Detailed Site Plan Special Permit

**DSP-11017
 SP-110002**

STAFF REPORT

SUBJECT: Detailed Site Plan DSP-11017
Special Permit SP-110002
Hyattsville Subway Sandwich Shop

LANDSCAPE PLAN

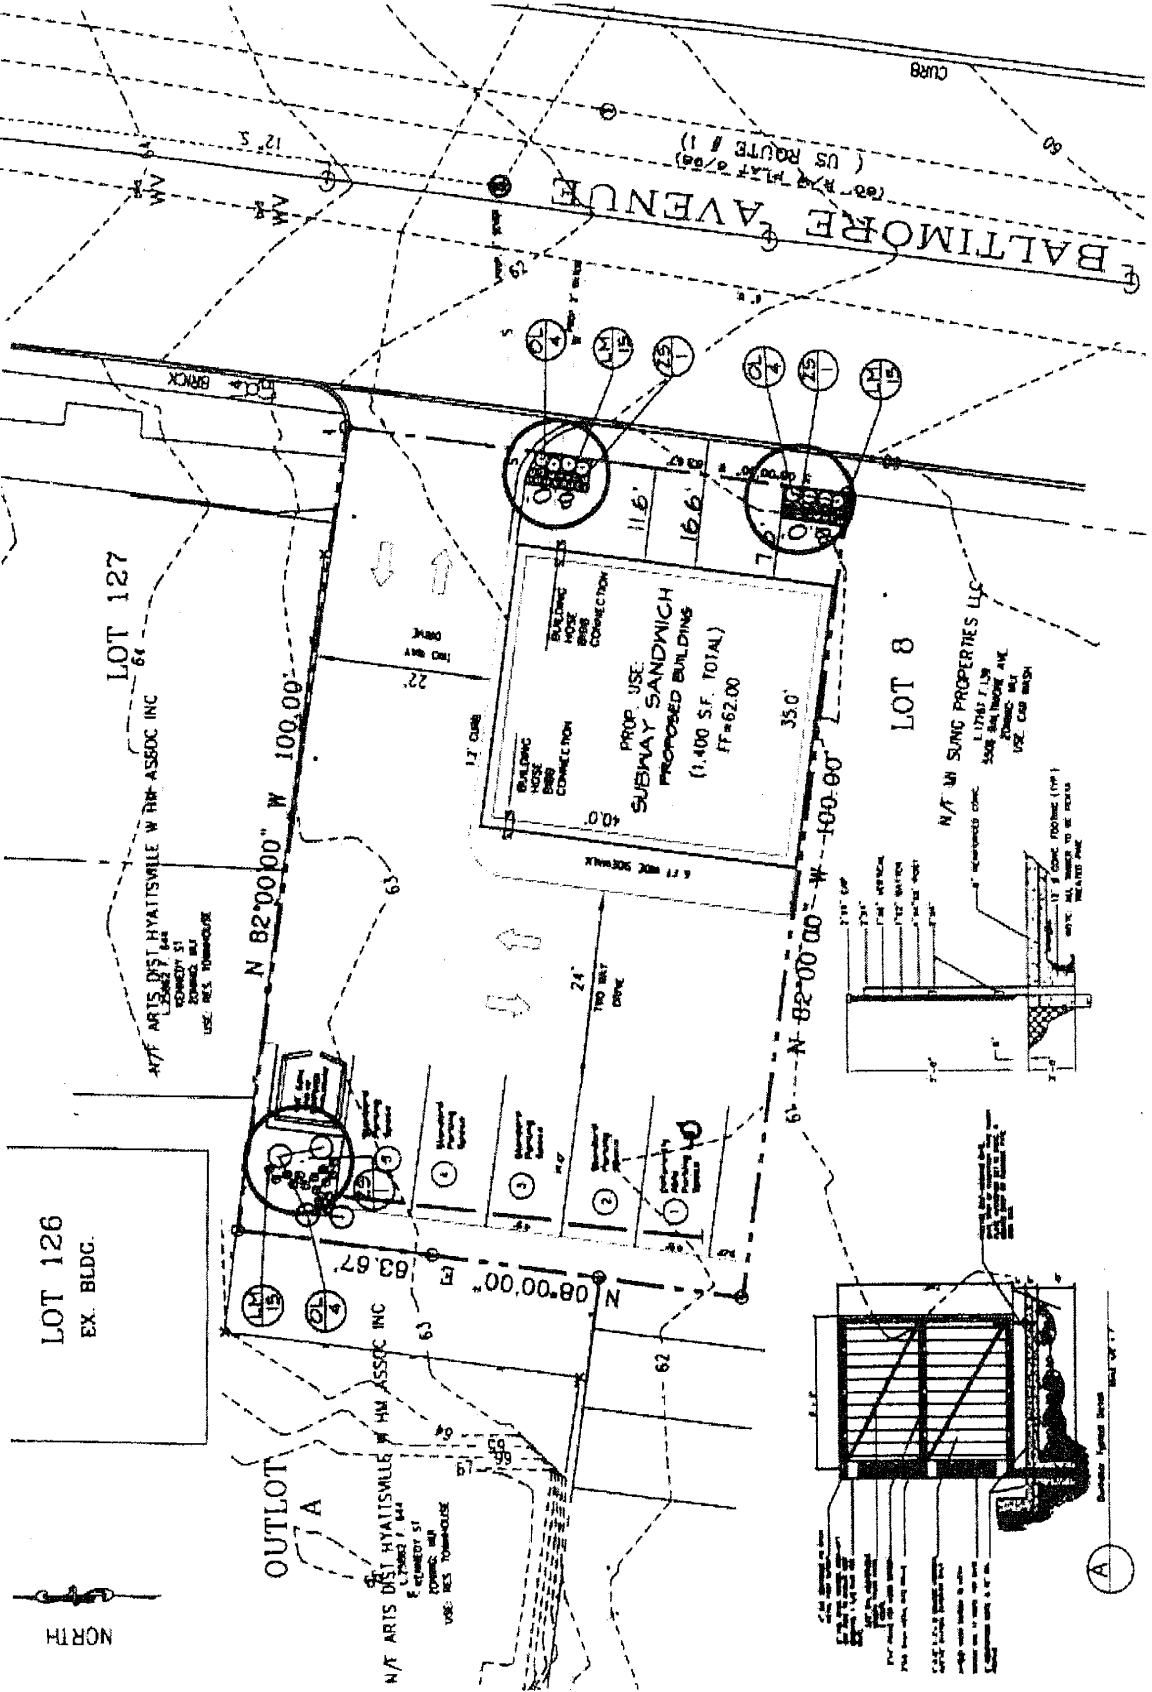
Comment: As the tree boxes shown do not meet this minimum requirement and because the streetscape is recommended to be redesigned prior to signature approval, staff will ensure that, in the redesign of the streetscape, the tree boxes meet this minimum requirement.

The tree boxes shown on the landscape plan are not detailed. It appears the dimensions on the plan show 4 feet by 8 feet. Either the tree boxes will need to meet the standard or an amendment to the standard must be requested. It appears there is adequate room on the sidewalk to accommodate a larger tree box.

SITE PLAN

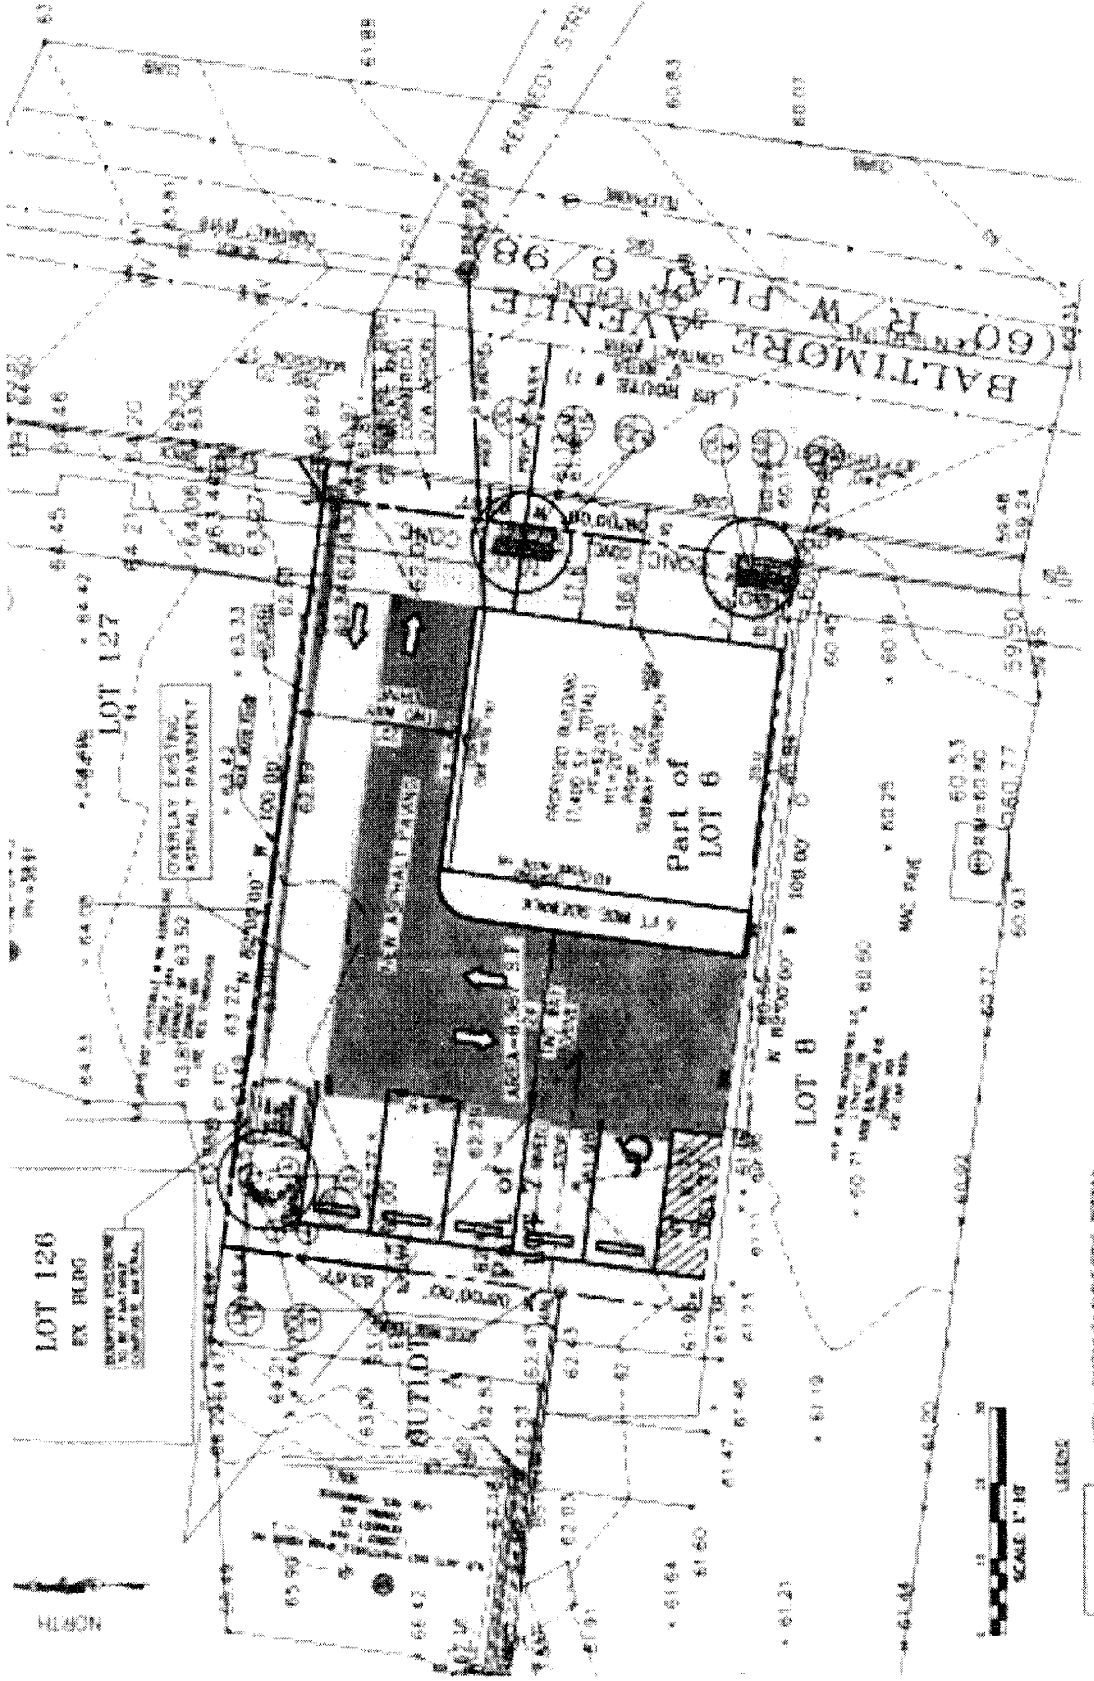
Comment: The detailed site plan, but not the landscape plan, indicates two semicircular light fixtures in plan view. No detail for the fixtures is provided. The only additional information regarding lighting is provided in Note 19 which states: "Adequate lighting shall be provided that will not cross over to neighboring property and to minimize overall sky glow." This is insufficient to evaluate conformance to this development district standard. Additionally, there are no lights indicated on the front of the building or at the rear of the site. Staff has included a proposed condition of approval that would require, prior to signature approval, the applicant to revise the detailed site and landscape plans to include a detail and additional lighting that would address the front of the building and the rear of the lot. Further, in order to ensure that off-site light intrusion into adjacent and environmentally-sensitive areas designated by the 2005 *Approved Countywide Green Infrastructure Plan* is minimized, and so that sky glow does not increase as a result of this development, the detail provided shall reflect a full cut-off optical fixture.

The site plan shows a dumpster enclosure. An elevation of the enclosure and the materials used should be noted on the plans to ensure the standard is being adhered to.

- j. The handicapped parking space shall be dimensioned as 16 feet by 19 feet.
- k. The dumpster detail shall be revised to indicate face brick to match the color of the brick to be utilized on the first story of the building as the external sheathing architectural material.

- l. General Note 4 on the detailed site plan shall be corrected to indicate that the proposed building height is 20 feet, 1 inch as indicated within the building footprint and by the submitted building elevations.

- m. General Note 6 on the detailed site plan shall be revised to indicate the square footage of the landscaped area on the site as green area, not "0 square feet" as is currently indicated.
